20-110MPR – BATES AND BROWN BARBERSHOP

Proposal for exterior modifications to an existing tenant space located within Bridge Park, Building B4.

20-110MPR
Minor Project Review
Bates & Brown Barbershop
6562 Longshore Street

Proposed Elevation

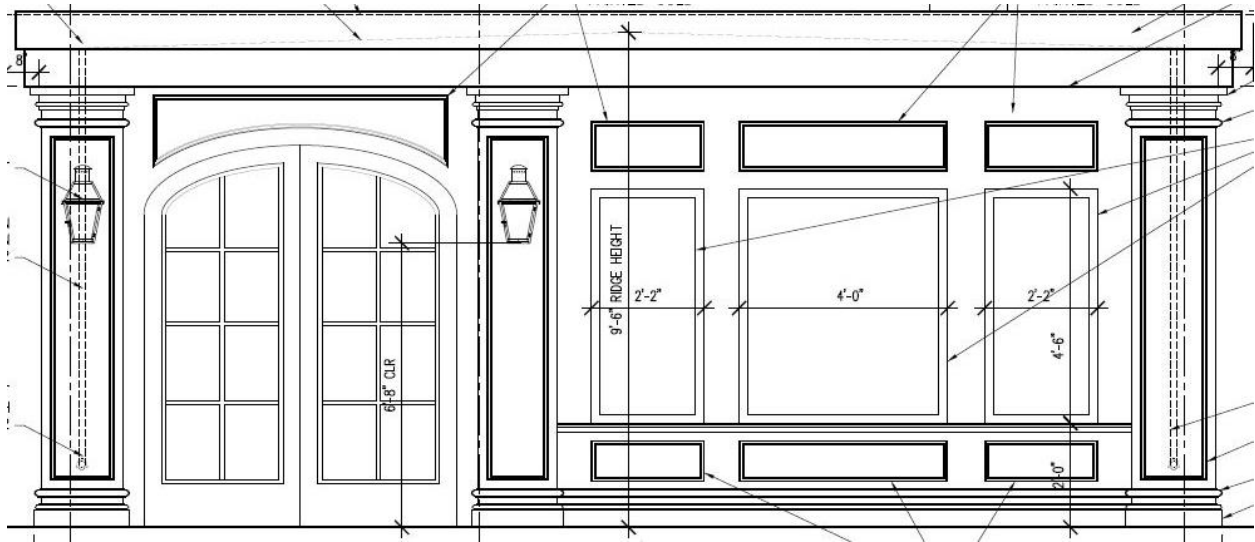
The proposed modifications include a new, black aluminum storefront system with a black door to match. The entry is an arched double door located on the left side of the storefront. Above the door and around the windows on the storefront are trim details, which are to be painted gold. On either side of the entry is a column feature adorned with a gas light. The applicant is proposing a Low-E tinted glass to match the existing. It is unclear whether this satisfies Code Section 153.062(H), therefore, Staff is recommending the applicant provide more details on the window tinting prior to submittal for building permits, subject to Staff approval.

The applicant is also proposing an overhang, which spans the entire length of the storefront. The aluminum overhang will also be painted black to match the storefront, and contains a number of recessed can lights on the underside. The overhang encroaches into the ROW by 1-foot, 4-inches which is permitted by the BSD Code. The City's Engineering Division has reviewed the encroachment and is accepting.

For first floor elevations, 60 percent transparency is required per the BSD Code. Currently, 60 percent transparency is provided. This proposal, which reduces the size of the window openings, will further reduce the transparency provided to approximately 56 percent. Staff is supportive of an Administrative Departure for transparency requirements Administrative Departures may grant deviations from a numeric requirement up to 10 percent. In this case a 10 percent reduction results in a transparency of 54 percent, which the proposed 56 percent transparency falls within.

- 1) The applicant provide more details on the tinted windows as to ensure Code compliance, subject to Staff approval.
